Product Change Notification

TPiS 1T 1086 L5.5 / 7452 – 16.10.2019

Affected Bau number: 9638 7452

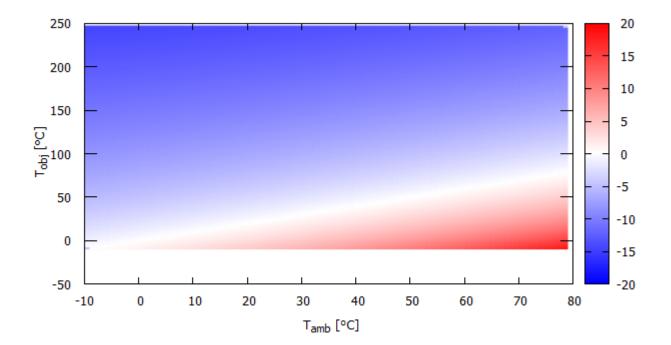
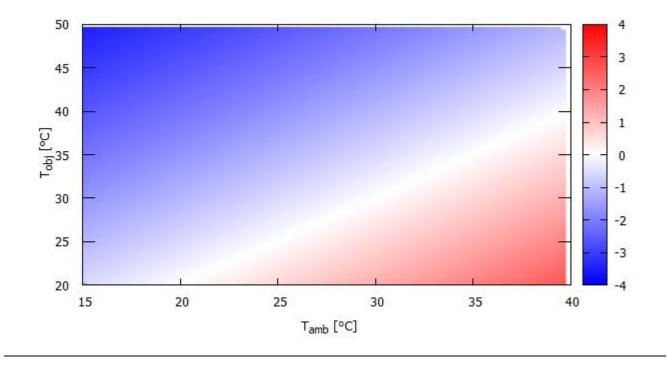
Despite having a black body covering the full field of view with a controlled surface temperature, stray light is affecting this part. The contribution of stray light is visible in the signal. The signal of the thermopile is stronger for a plate type black body as compared to a hollow tube black body. This in turn will likely lead in the application to temperatures, which are displayed lower as previously in case the object temperature is higher than the sensor temperature.

Based on a two-point measurement in front of a flat black body for a set of 6 samples, we demonstrate the following expected mean deviation (T object before change) – (T object after change) = $\Delta T[^{\circ}C]$ for two different object and temperature ranges:

In order to keep the behavior for the parts after change comparable to the behavior before the change, you must scale the calibration factor as given by the component EEPROM by a factor of

$$k \rightarrow k / 1.127$$

This is described in the product specifications in section 8.5. If your code is foreseeing an emissivity correction, you may alternatively scale the emissivity by the factor of

$$\epsilon \rightarrow \epsilon / 1.127$$
